CHANGE ORDER NO. 2

PROJECT MAWTF Biosolids Improvements Project CONTRACT NO. 13823

ENGINEER Donohue & Associates, Inc.

[Marquette WWTF - 960 Unsuitable Soil Area 7-20-23.pdf](#), [DE84EDA0-EE18-443F-97E0-B078E6D4456E.JPG](#), [2000000000040164.JPG](#), [515910DF-EE74-4A77-8CEE-FFCDB018F18F.JPG](#), [39E72171-9906-4405-A9C1-19118F6A7F31.JPG](#)

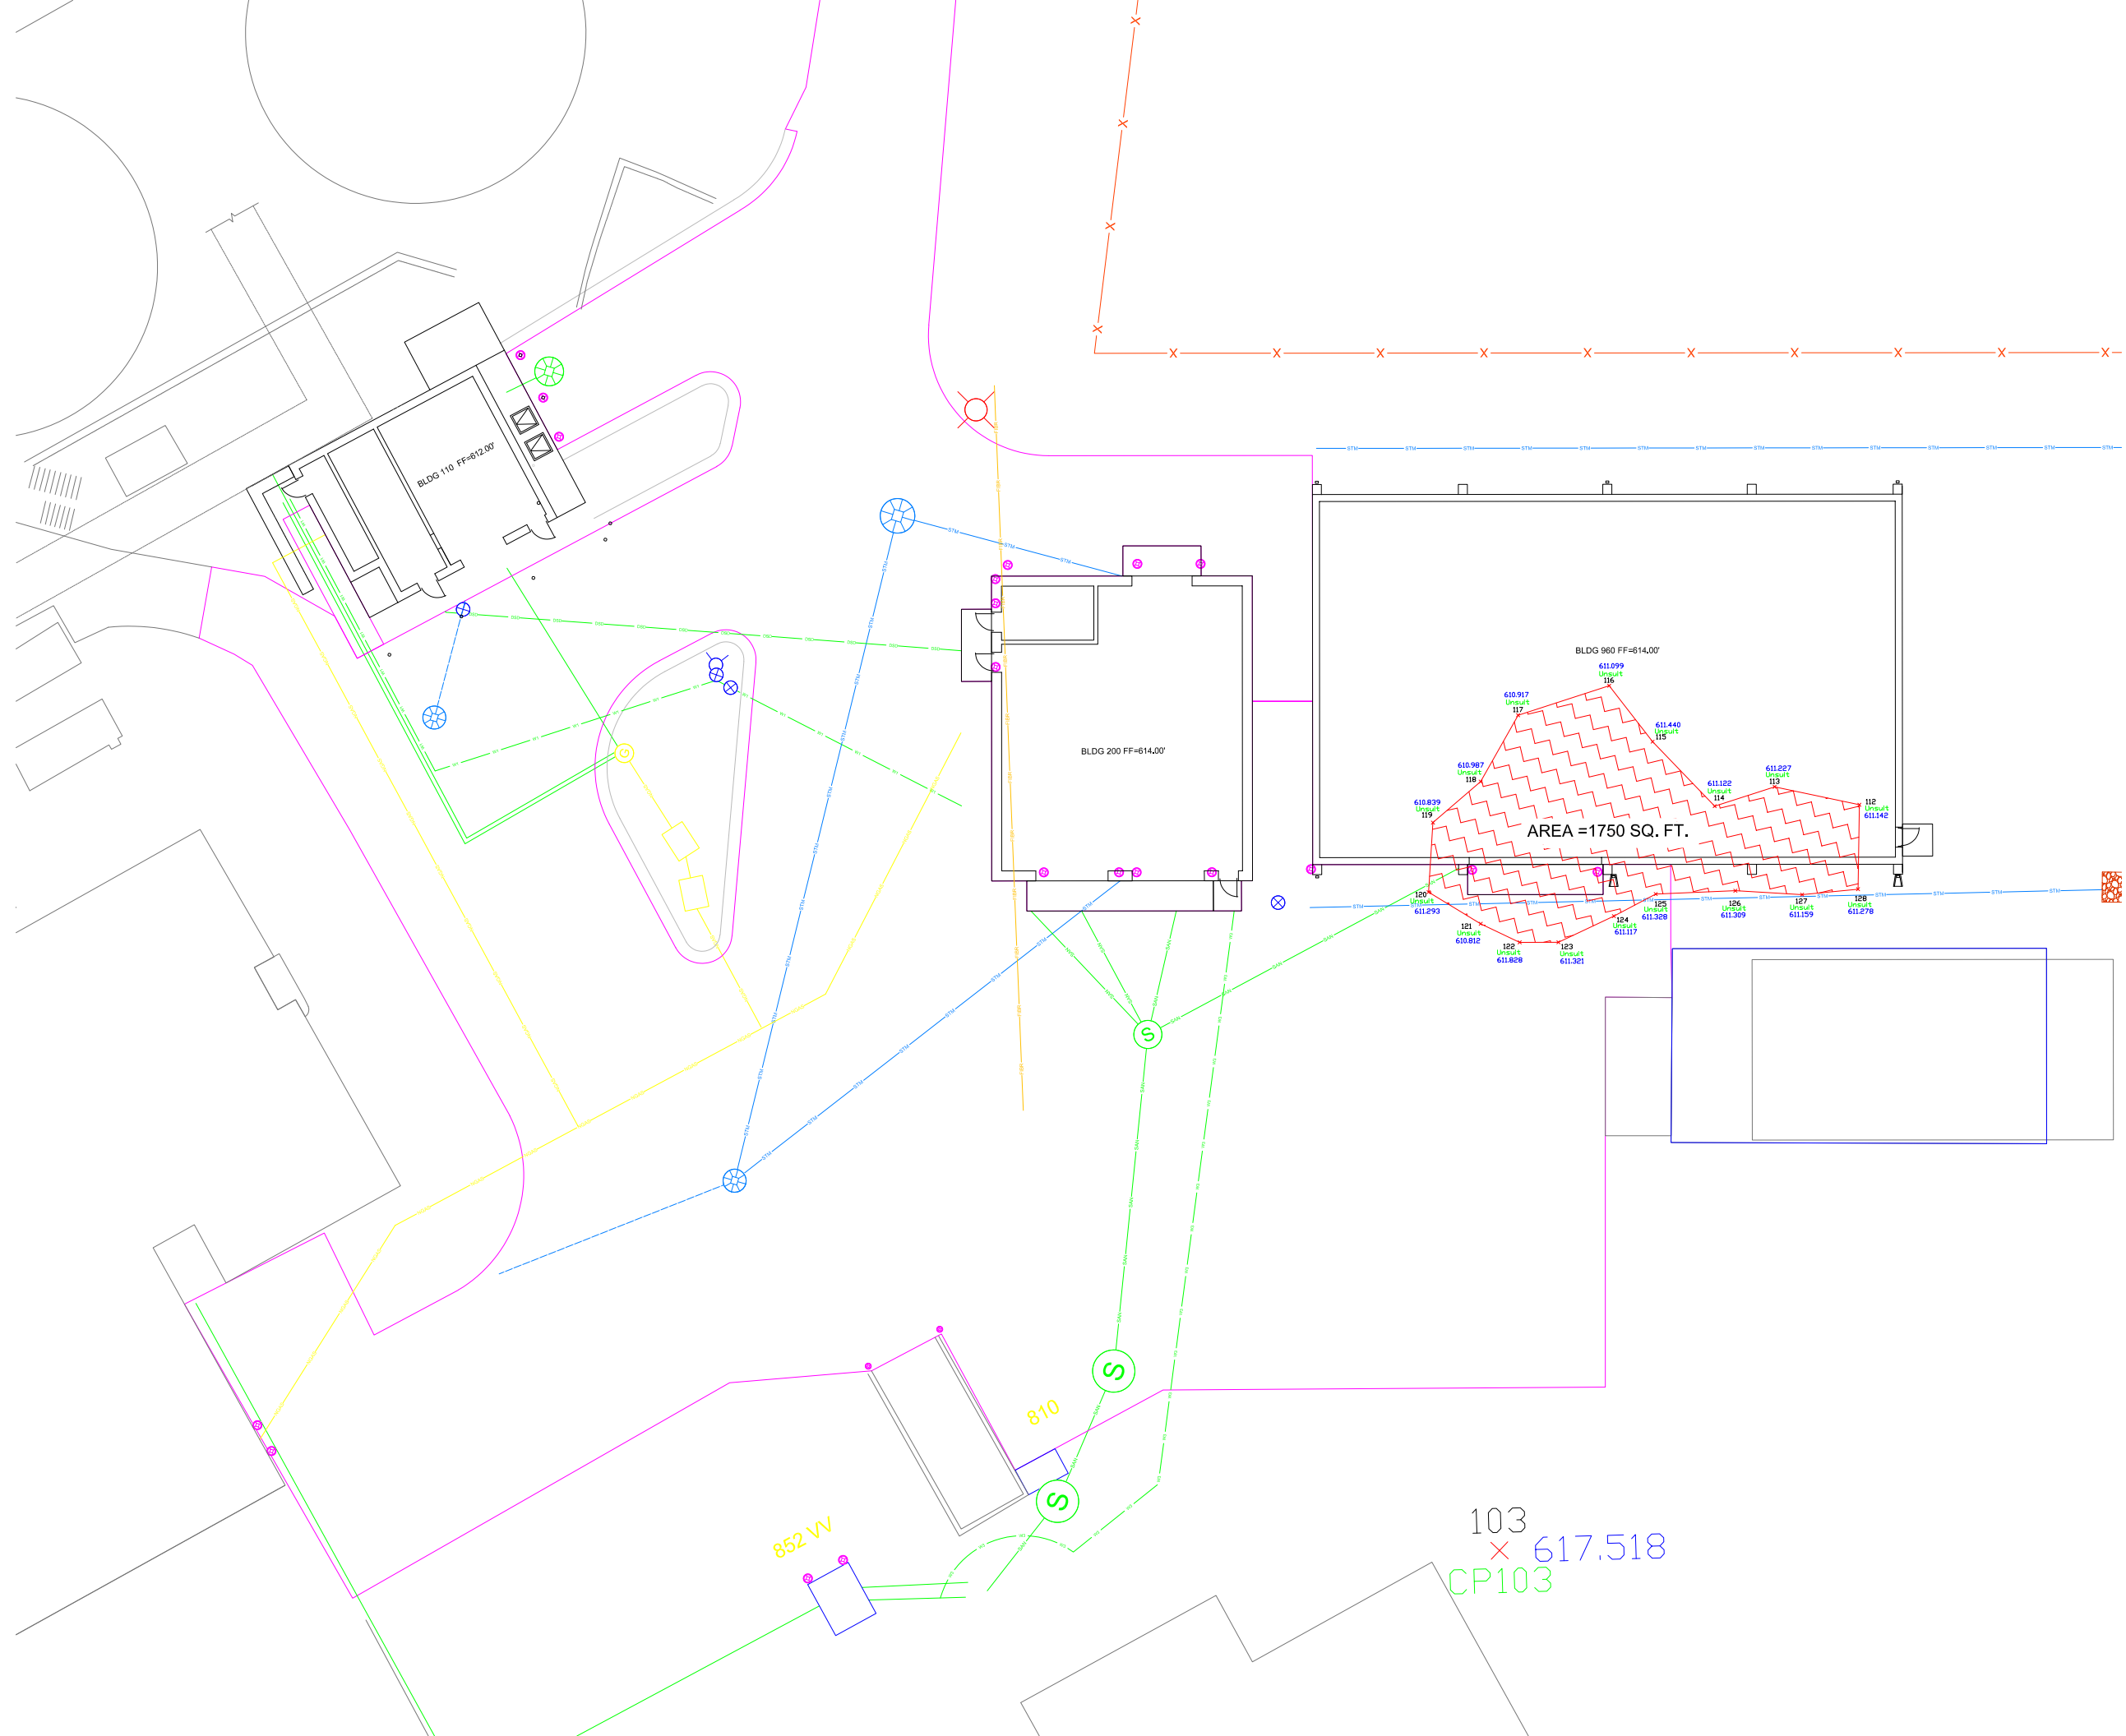
On 7/20/23 while digging to the appropriate elevation associated with the new building 960 structure, there was an area witnessed with organic material at approximately 611.00'. We made the sub cut down to 608.00' successfully removing the majority of the organic material, but then ran into buried broken up foundation (concrete 5"-8" with rebar). In discussions with the rigid inclusion contractor, this material would cause false refusal, and the drill will not be able to penetrate.

Upon discovery, a meeting was held on 7/20/23 with the owner, Donahue, GEI, Subsurface Constructors, and MJ Vandamme. Subsurface had indicated that the material would need to be removed in order to perform their operations. Concluding the meeting, the direction was recommended for the contractor to mark the perimeter extents of the area affected and remove unsuitable soils and debris so as to be replaced with structural back-fill compacted in lifts. GEI and Coleman to be onsite to witness the operation. Please advise if acceptable to perform this work on a T&M basis to maintain project schedule.

Please reference attached PDF and pictures.

Verify required subgrade preparation with RI designer. Provide a proposed T&M basis with a not to exceed value for review by Donohue.
